Faiza Industries Ltd.

15th June 2017

Observations

Observation : Production Shed

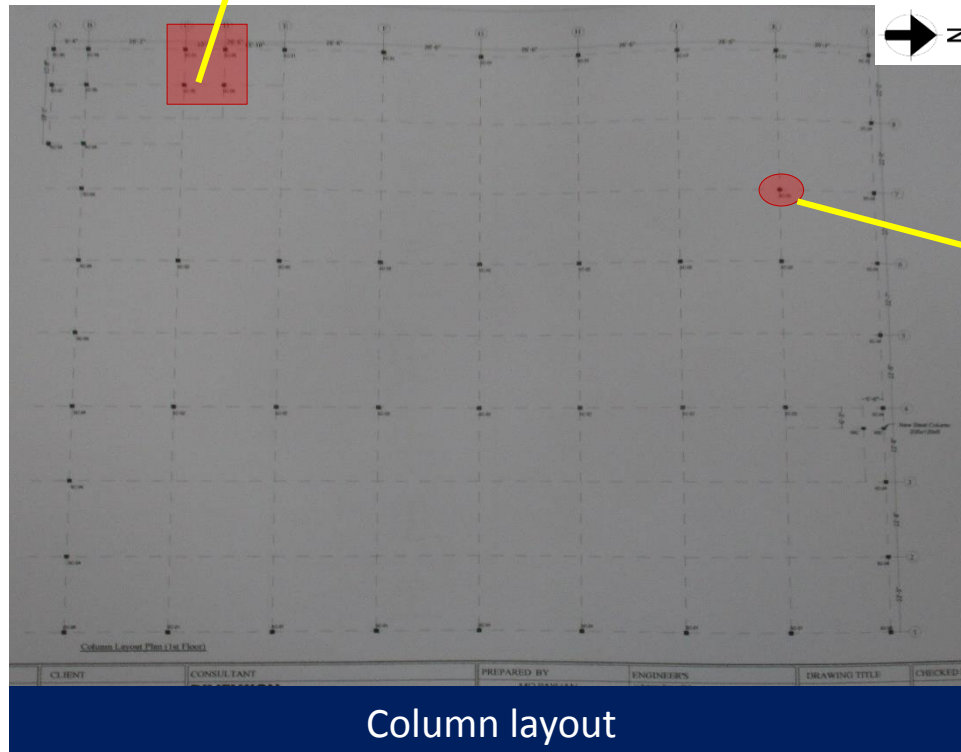
Discrepancies between drawings and on site condition

Misplaced Column

Missing Column

Column, main beam & sub-beam sizes were not fully matched with provided drawings. Building engineer is required to survey the as built condition and produce as built drawings.

Item No.	Observation	Recommended Action Plan	Recommended Timeline
1	(Production Shed) Discrepancies between drawings and on site condition	Engage an Engineer to produce an “as constructed” drawings which reflect the actual site dimensions with complete structural information.	6-weeks
2	(Production Shed) Improper connection	Qualified Structural Engineer to investigate the connection of steel joint and suggest necessary remediation.	6-weeks
3	(Production Shed) Improper connection	Remedial works to be carried out.	6-months
4	(Production Shed) Loose and poor connection of bracing.	Upgrade the connection of bracings.	6-weeks
5	(Production Shed) Loose and poor connection of bracing.	Tighten loose bracings.	6-weeks
6	(Production Shed) Lack of lateral load resisting system	Building engineer to check the lateral stability of the building against lateral loading.	6-weeks
7	(Production Shed) Lack of lateral load resisting system	Implement the recommendation of engineering assessment.	6-months

Observation : Production Shed

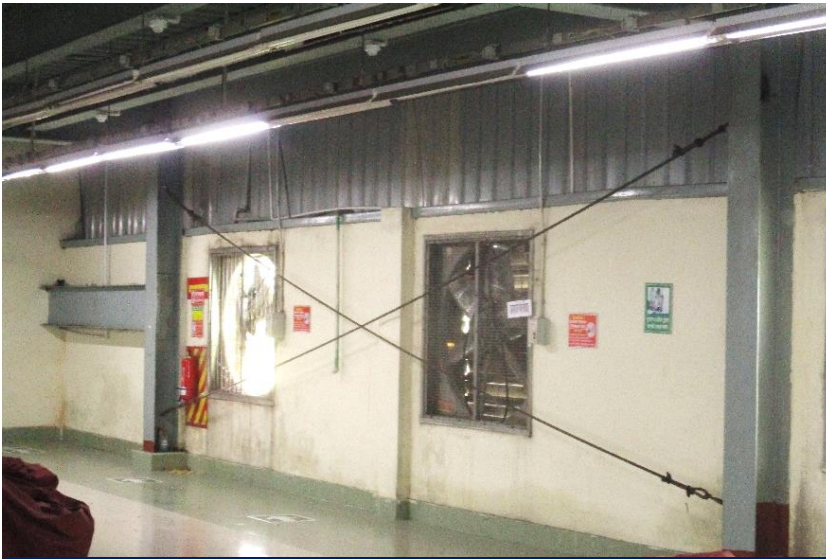
Improper connection

Tear on column-rafter joint

Additional steel plate added to support rafter

Rafter is not connected properly with column at North side of the production shed.

Observation : Production Shed

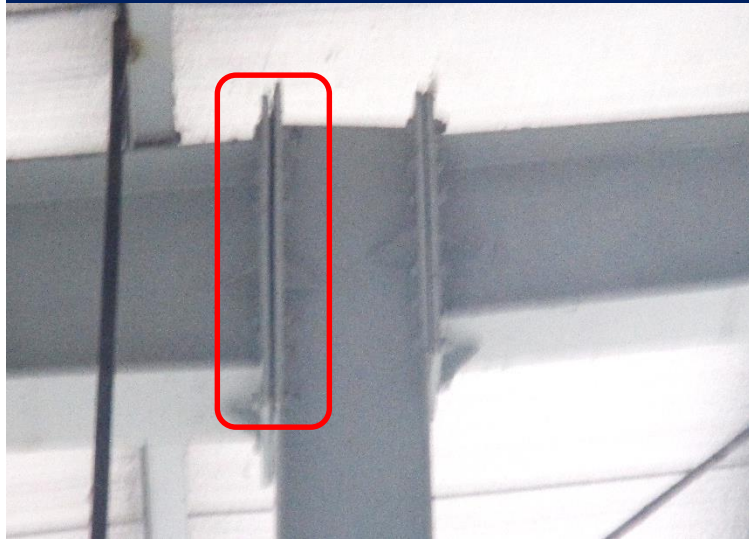
Lack of lateral load resisting system

Lateral load transferring system (compression strut) was not observed on roof. Factory engineer to check the lateral stability system of the building against lateral loading.

Observation : Production Shed

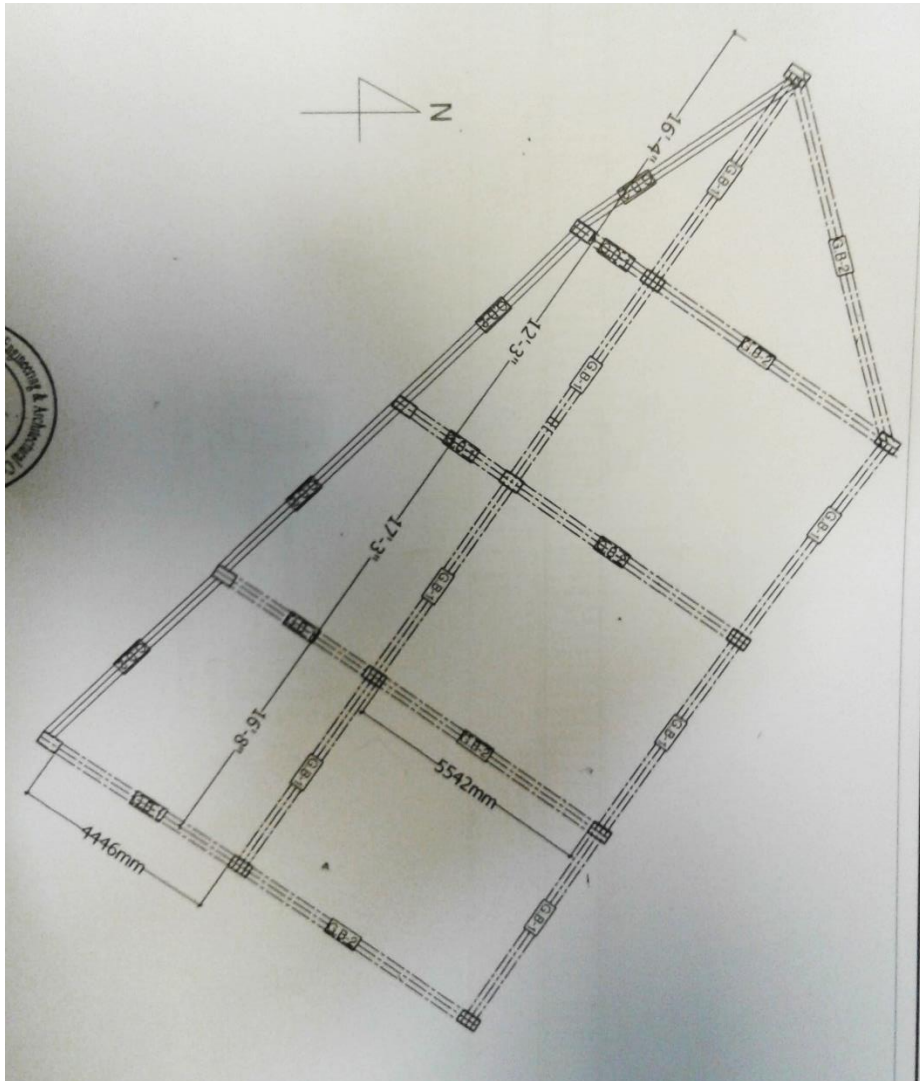
Gap between beam-column joint

Existence of significant gap in several connection.

Item No.	Observation	Recommended Action Plan	Recommended Timeline
8	(Production Shed) Gap between beam-column joint	Engage an Engineer to check that the connections are adequate.	6-weeks
9	(Production Shed) Gap between beam-column joint	Carry out suitable repair works where necessary.	6-months
10	(Utility-1) Mismatch in drawings	Building Engineer to update as-built drawing according to actual condition.	6-weeks
